## ADDENDUM

NO. 02

**PROJECT NAME:** 2024 Cy Ranch High School Additions And Renovations

**ADDENDUM DATE:** Thursday, November 20, 2024

#### AD No 1, Struct Item 5: To the Drawings, Sheet S302, "COLUMN & BASEPLATE SCHEDULE,"

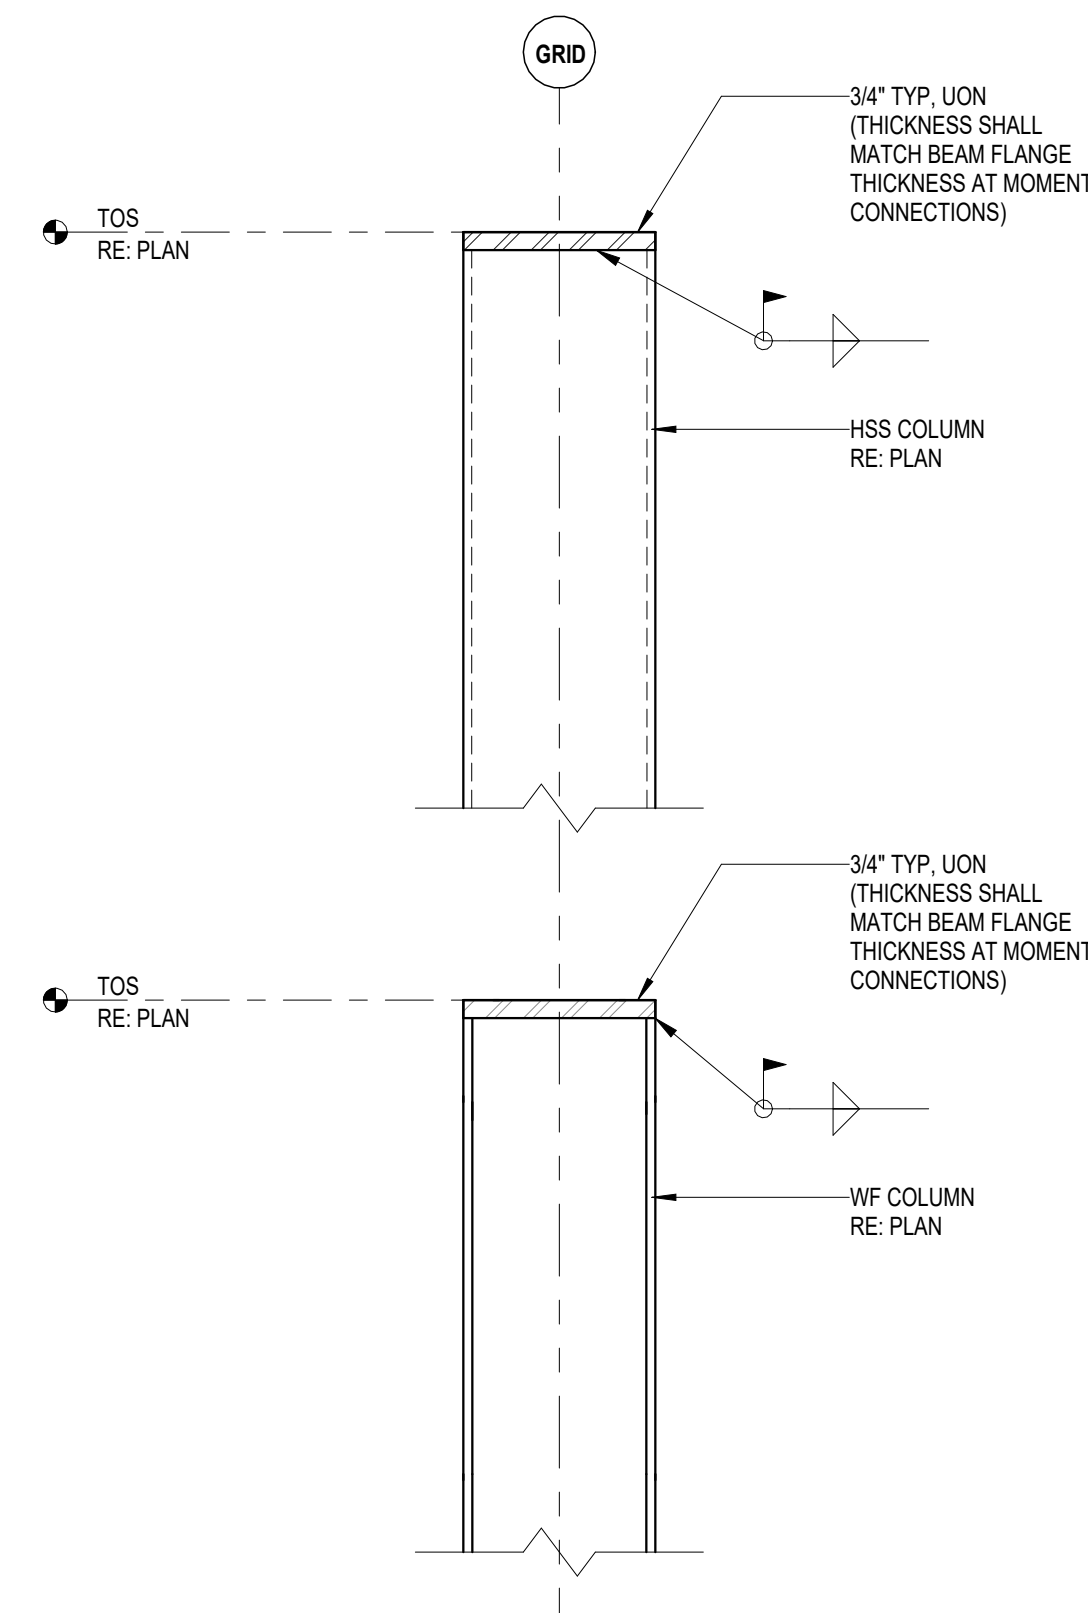
- 1) COLUMN (C3) is only being used as a Hanger, no baseplate.
- 2) COLUMN (C4) added with a concealed HSS post connection.
- 3) Detail 5 added.

### **AD No 2, Arch. Item 15: To the Drawings, Sheet AS1.03, "ENLARGED SITE PLAN - FINE ARTS & ATHLETICS"**

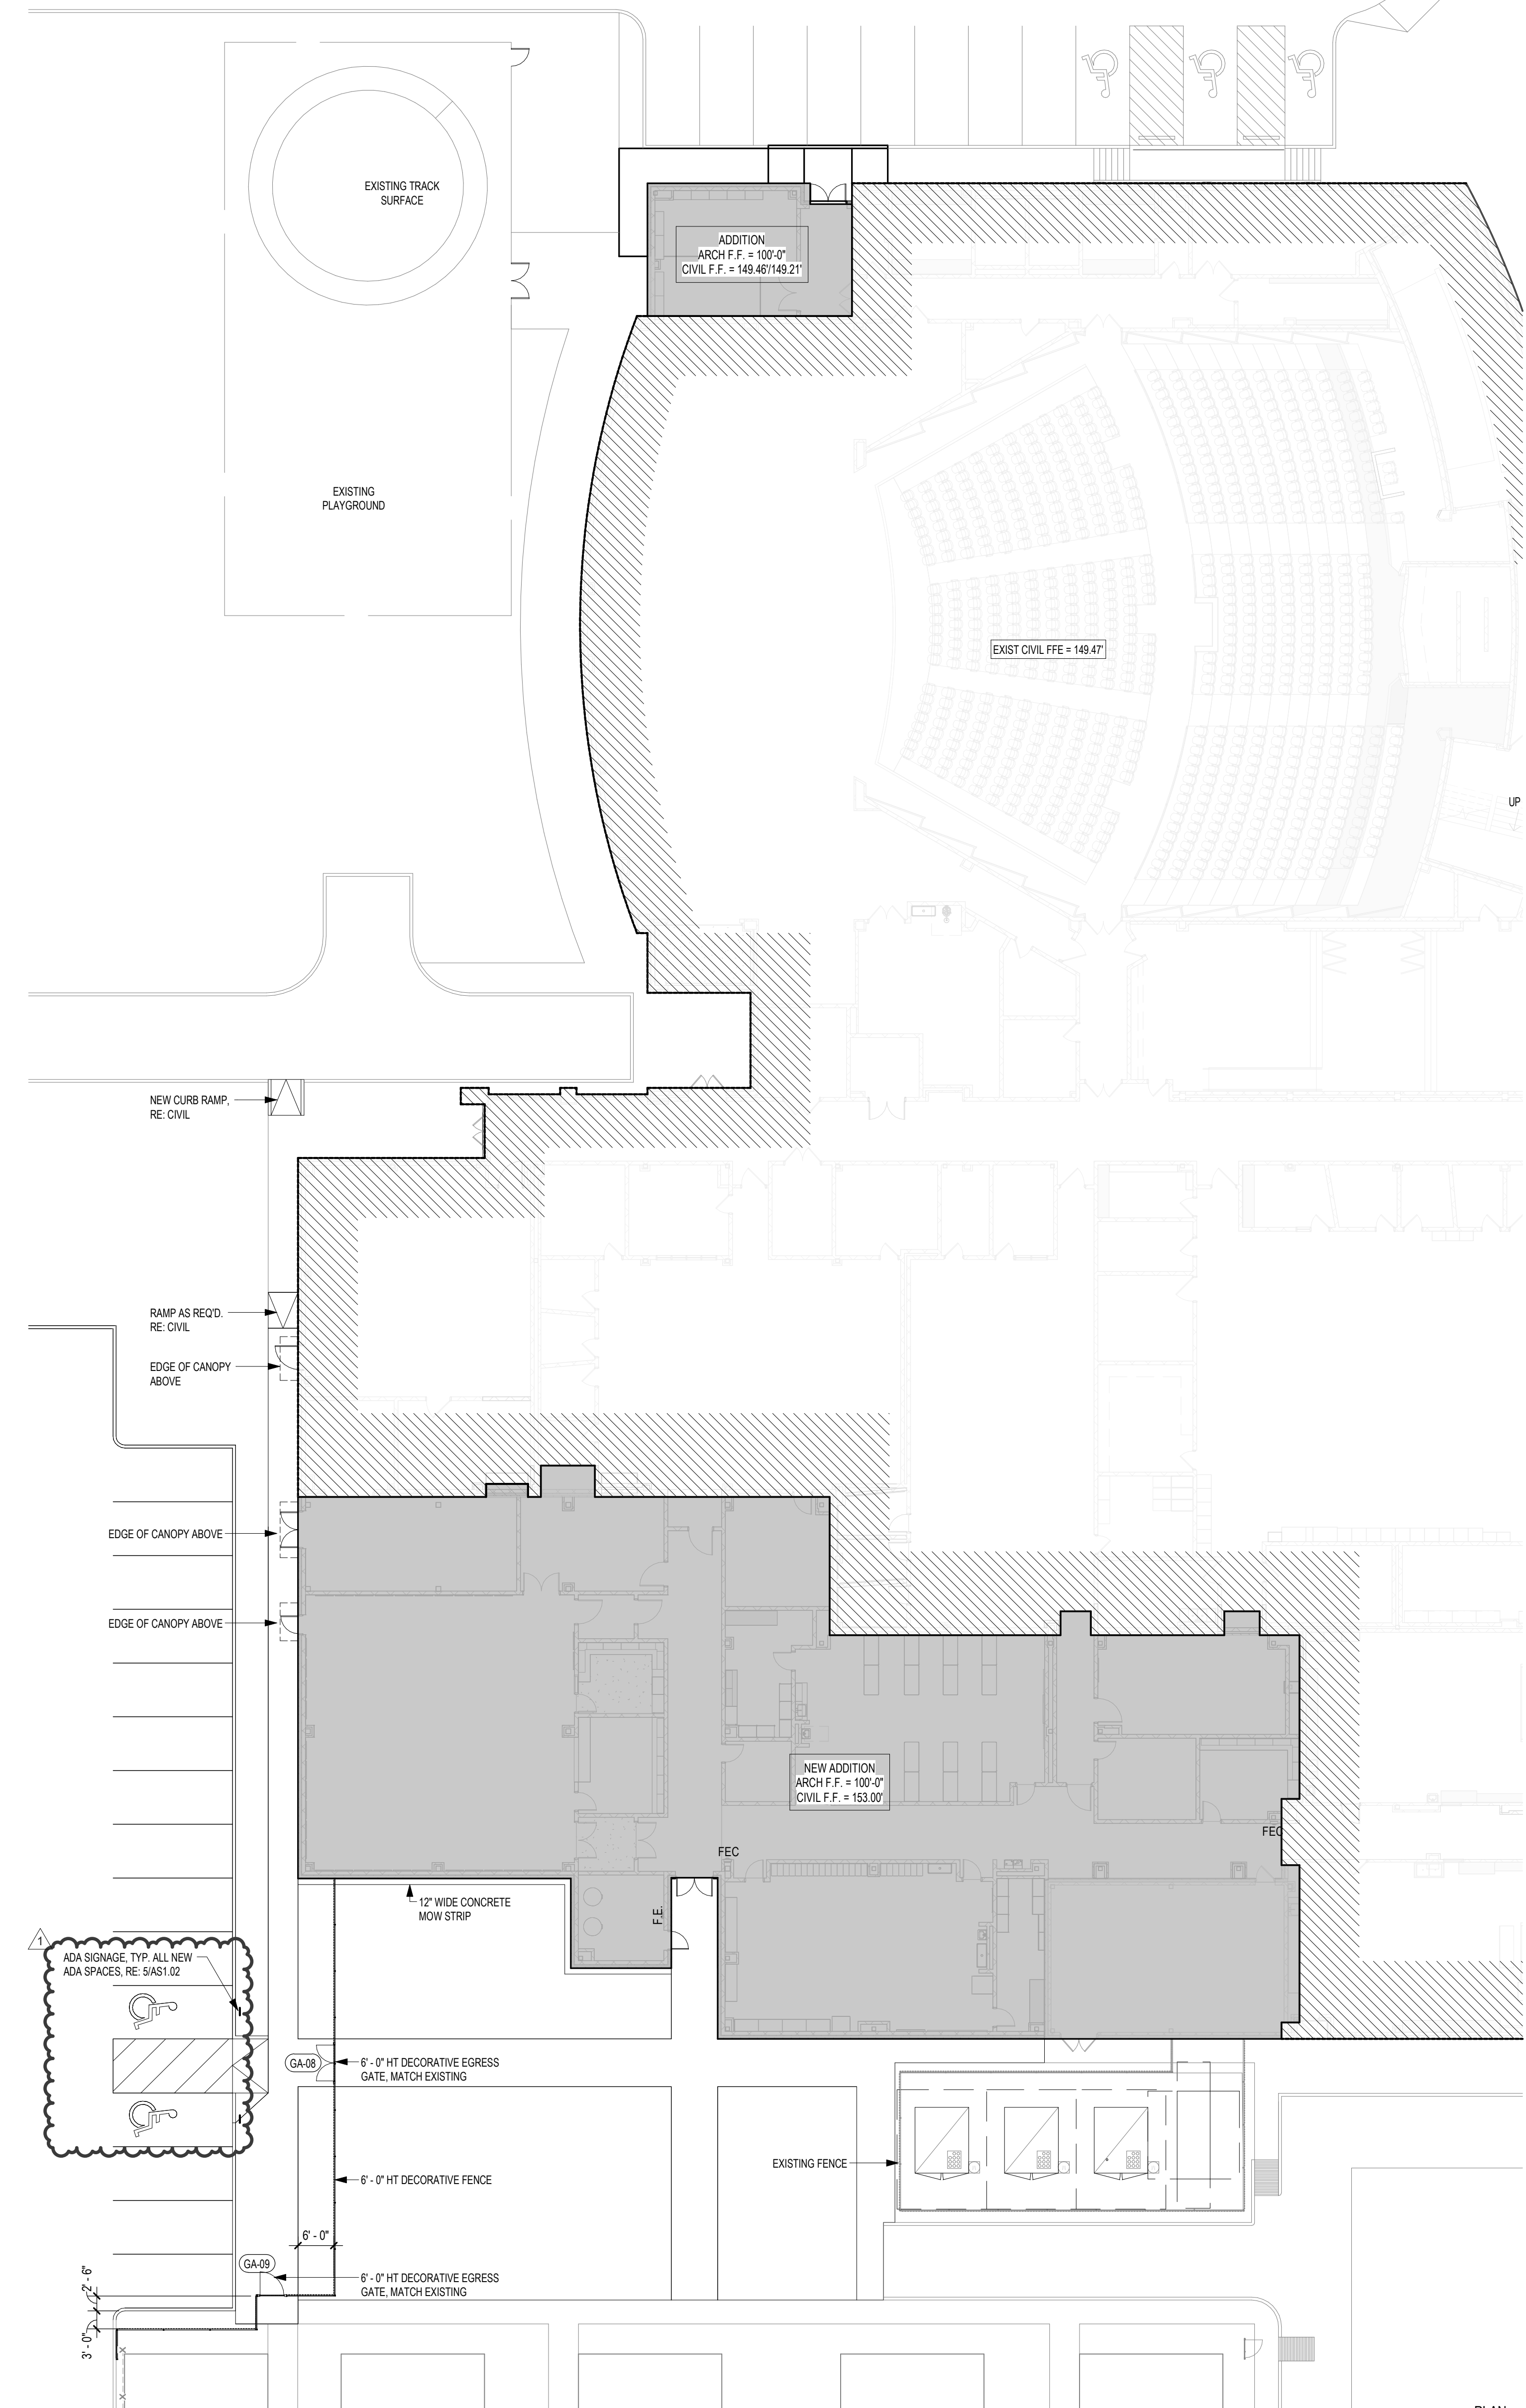
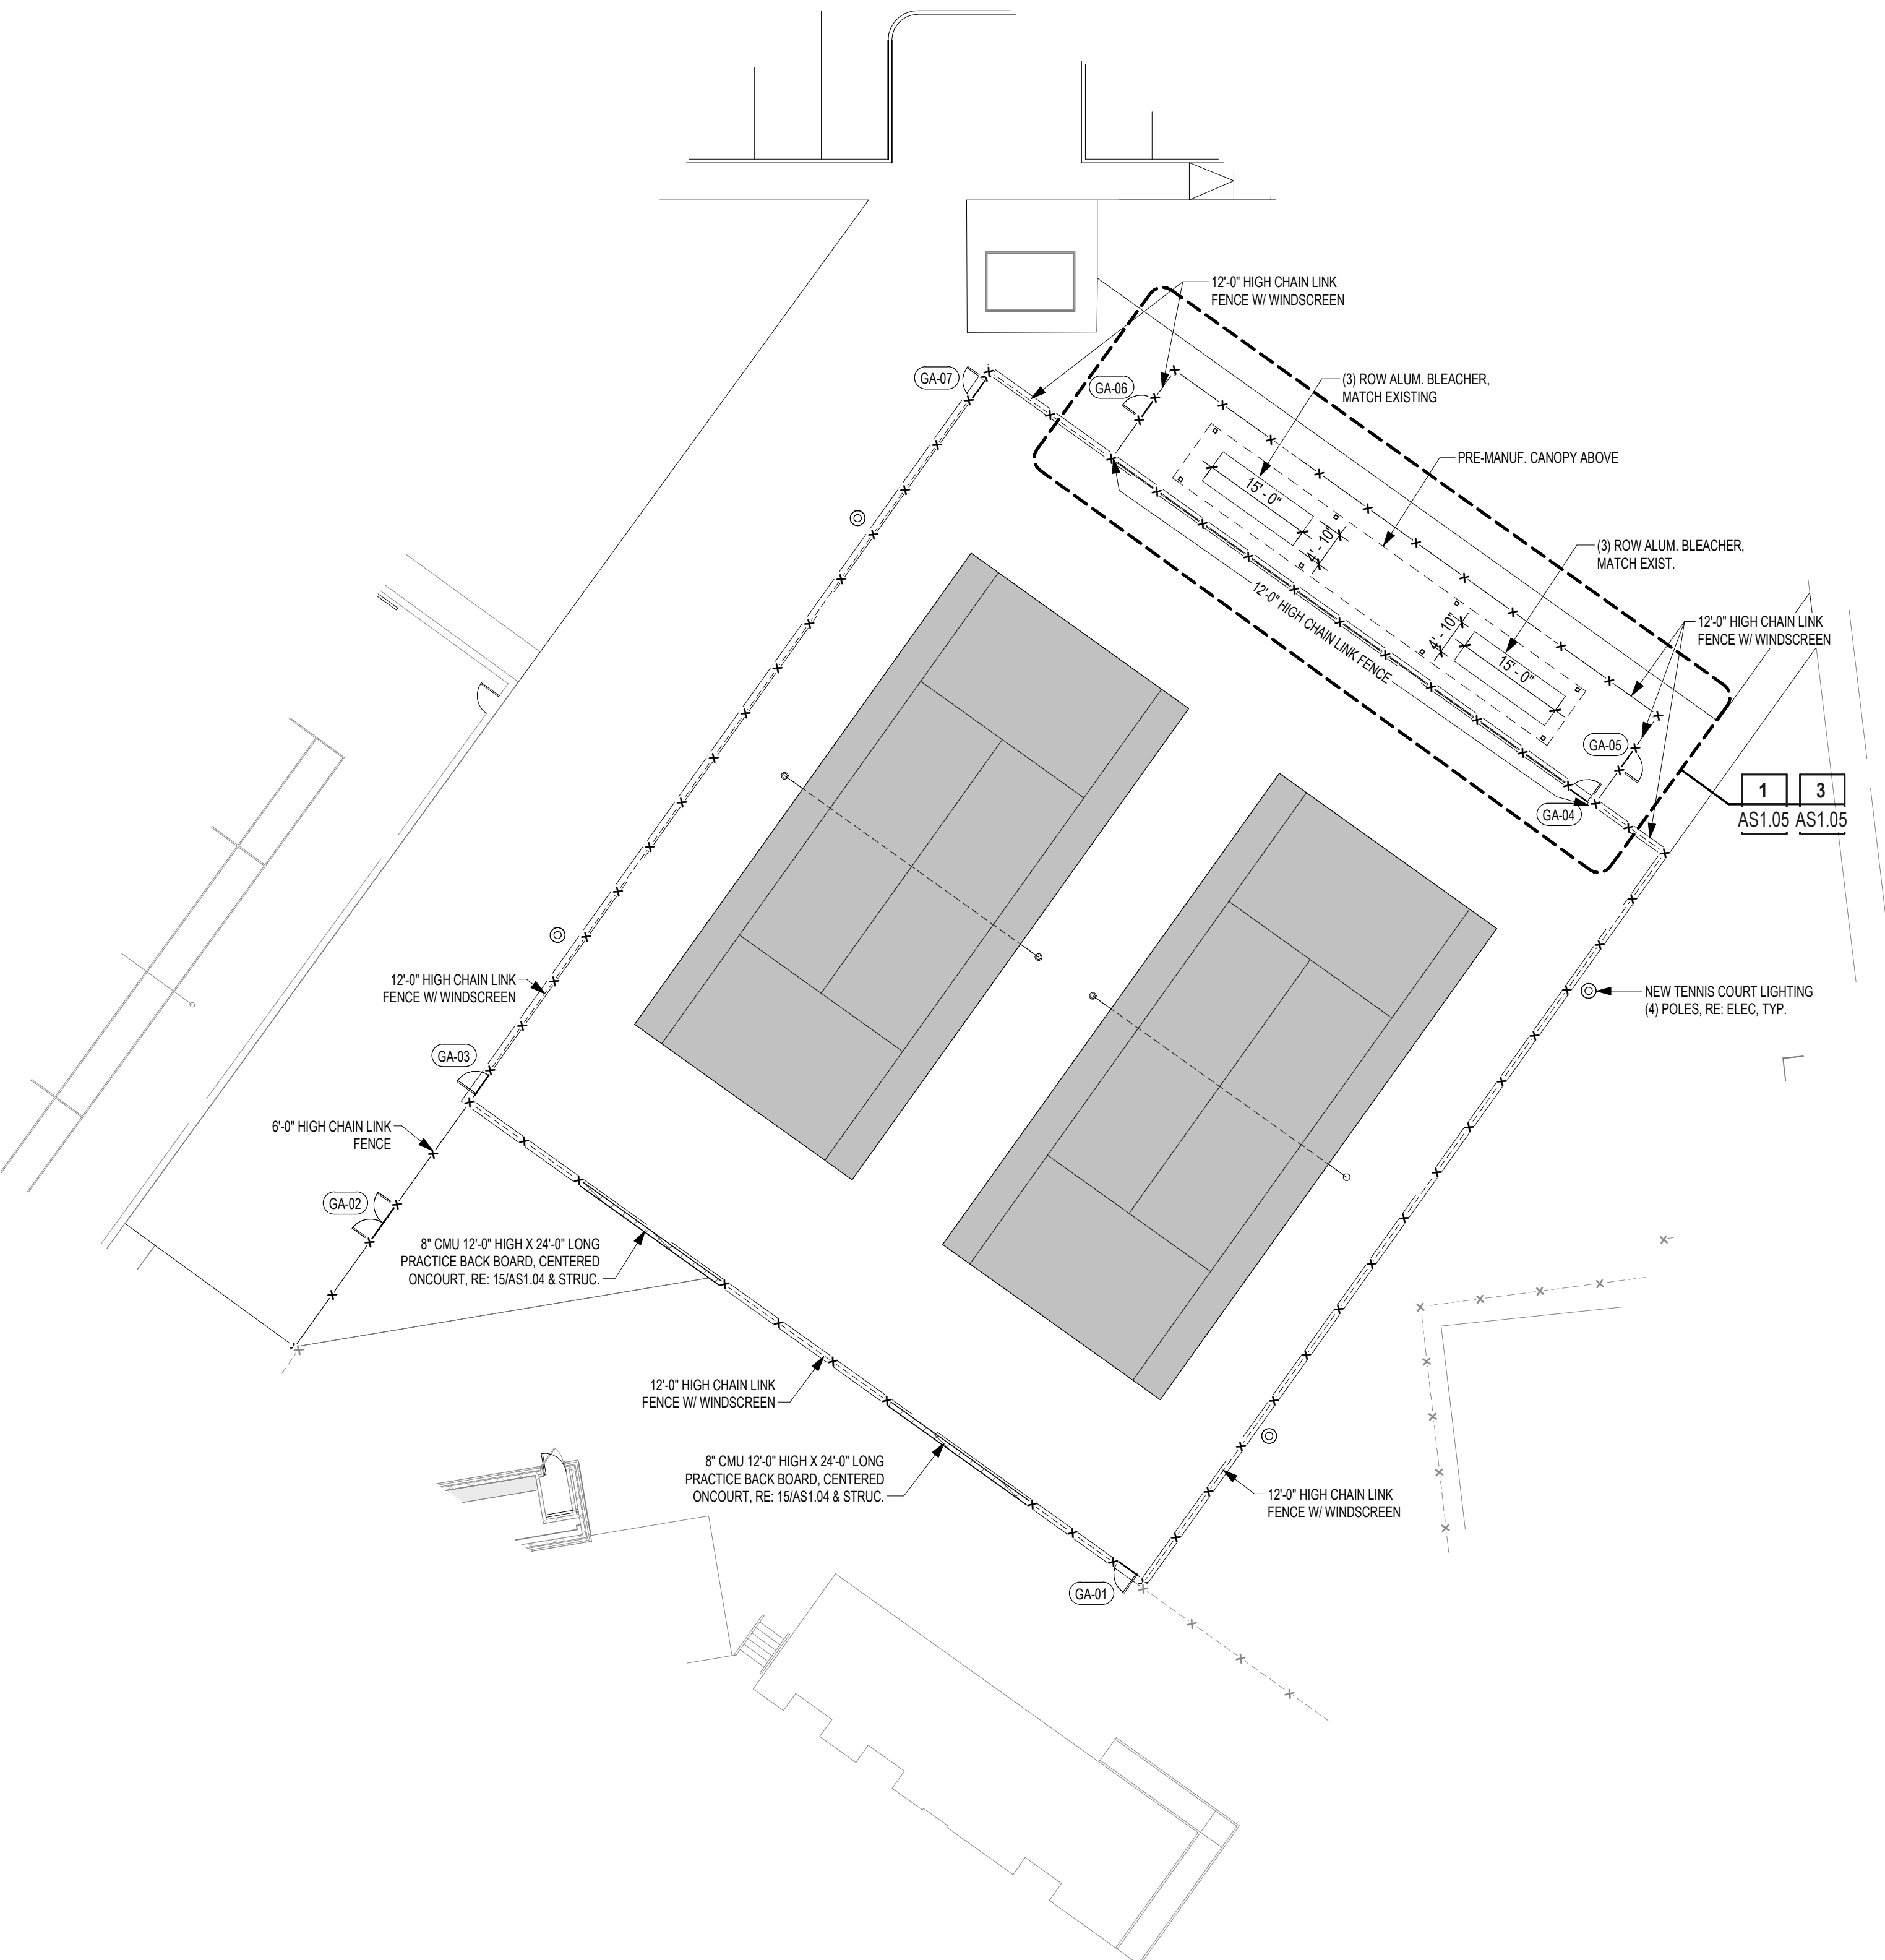
- 1) Detail 1, add ADA parking space signage per attached sheet.
- 2) Detail 5, add new ADA parking space signage detail in its entirety per attached sheet
- 3) AS - Gate Schedule, Revise notes per attached sheet
